Company	Trenz Electronic GmbH
PCN Number	PCN-20260226
Title	TE0820-05 DDR4 SDRAM and eMMC Change
Subject	BOM change
Issue Date	2026-09-03

This change affects all Trenz Electronic TE0820 SoMs: TE0820-05*.

Locate DDR4 SDRAM (U2, U3) on top side of TE0820-05 PCB:

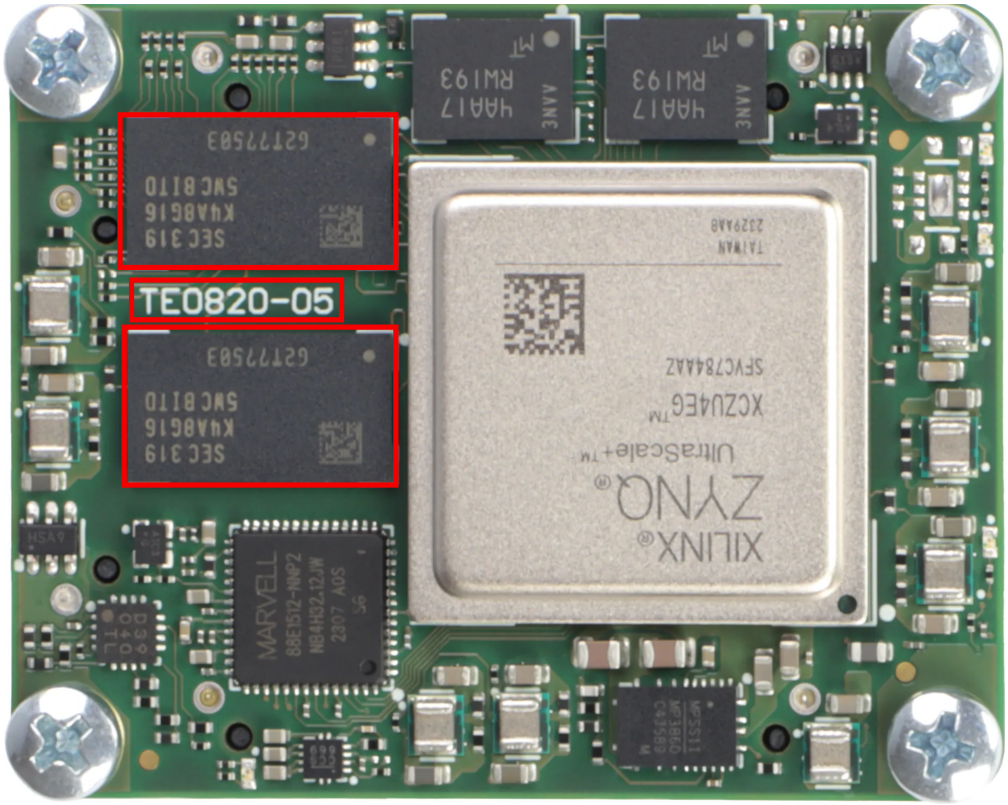
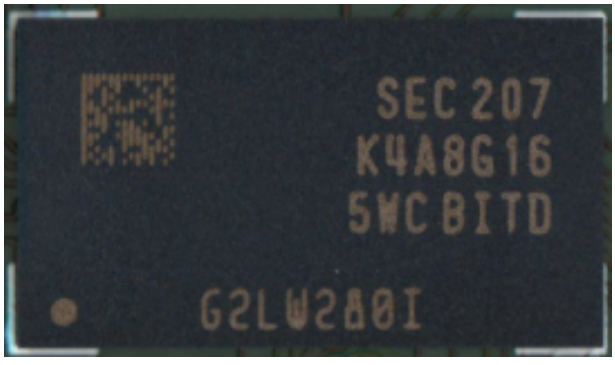
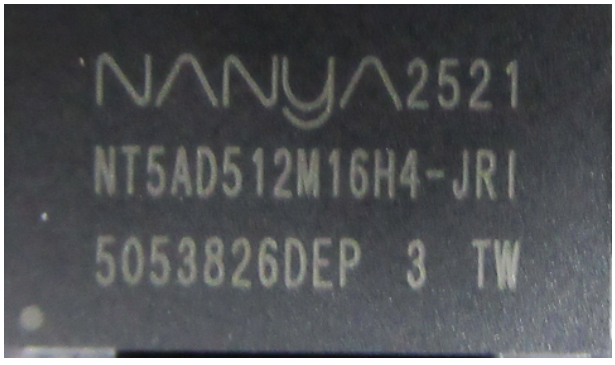
#1 Changed DDR4 SDRAM (U2, U3) from K4A8G165WC-BITDTCV to NT5AD512M16H4-JRI.

Reason: EOL of Component.

Impact: New DDR timings may be considered in designs. Timings used in Trenz reference design are due to following reasons still applicable without change: ZynqMP DDR4 Memory Setup.

old	new
K4A8G165WC-BITDTCV	NT5AD512M16H4-JRI

Locate eMMC (U6) on bottom side of TE0820-05 PCB:

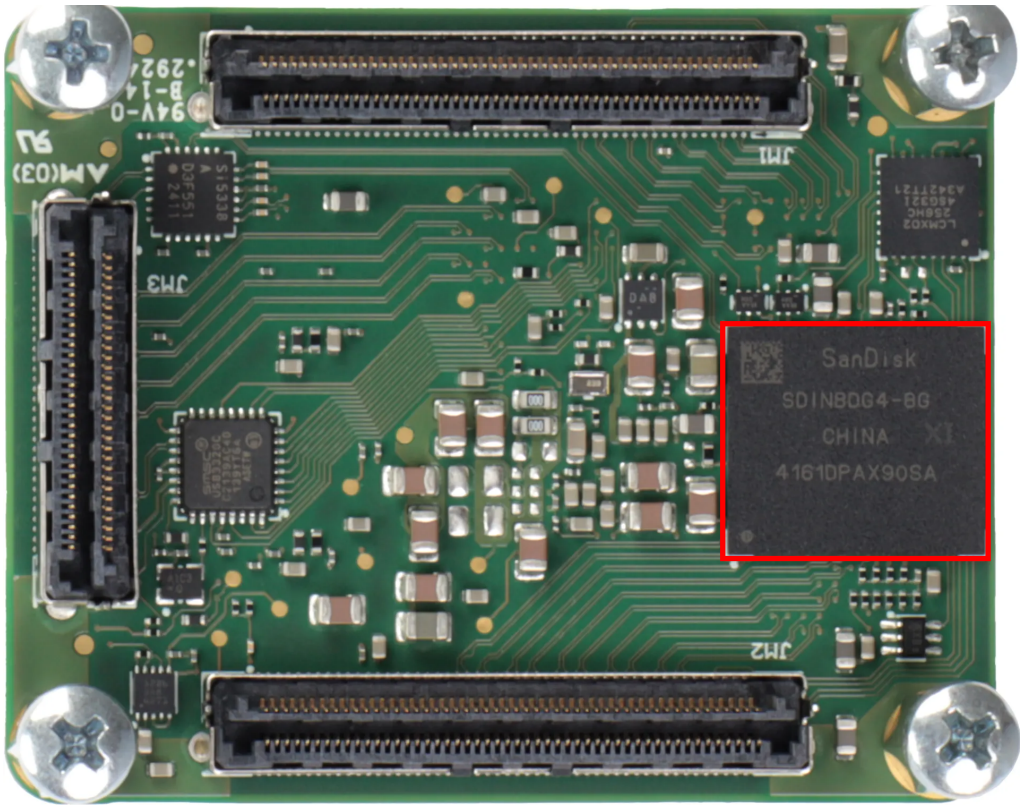
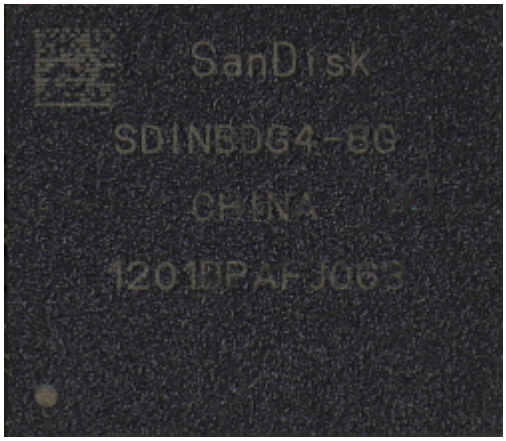
#2 Changed eMMC (U6) from SDINBDG4-8G-XI2 to IS21EF08G-JCLI.

Reason: Supply chain improvement.

Impact: None. Replacement has same capacity as used on corresponding affected variant. Reference designs for Vivado were tested and work properly without any changes.

old	new
SDINBDG4-8G-XI2	IS21EF08G-JCLI
